Dhakarea Ltd (Extension)

22 January 2024

Structural Inspection Report

Observation-1: Inadequate number of material test report (Building-4).

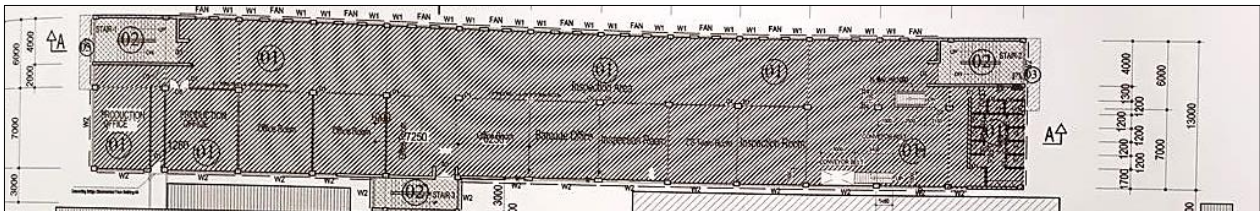
Description: 14 sets of concrete cylinder test report were available where 5 sets from columns. Also, out of 14 sets 7 sets have no average results. However, the number of cylinder test reports doesn't satisfy the frequency of testing requirement of BNBC. So, the building engineer is required to verify in-situ material strength of the building by taking minimum 4 number of concrete cores from lower tier columns.

Item No.	Observation	Action Plan	Timeline
1.	Inadequate number of material test report (Building-4)	The building engineer is required to verify in-situ material strength of the building by taking minimum 4 number of concrete cores from lower tier columns. Incorporate the equivalent strength in the design report.	within 6 weeks

Observation-2: Live load limit doesn't comply with the BNBC requirements. (Building-4)

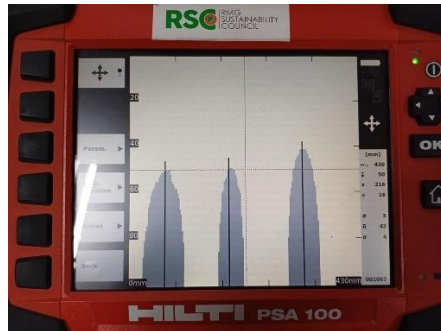
Description: In the prepared live load plan, 2 kPa (42 psf) live load has been considered for production area where 3 kPa is minimum requirement as per BNBC 2006. The building engineer is required to revise the design report based on updated floor live load plan and in-situ material strength. Submit design documents to the RSC for review.

2.	Live load limit doesn't comply with the BNBC requirements (Building-4)	The building engineer is required to update the floor live load plan and revise the design report based on in-situ material strength. Submit design documents to the RSC for review.	within 6 weeks

Connection between Building-4 & Fire Pump Room

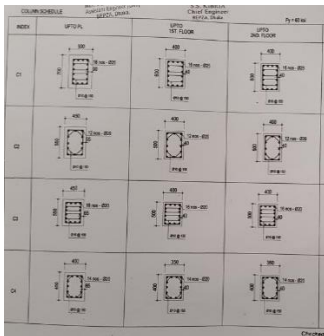
Description: Structural connection between Building-4 and Fire Pump room is found at ground level. The building engineer is required to consider the connection in the design documents.

3.		Carry out suggested remedial works if required.	within 6 months
4.	Structural Connection between Building-4 & Fire Pump Room	The building engineer is required to consider the structural connection in the design. Otherwise, separate the structures	within 6 weeks
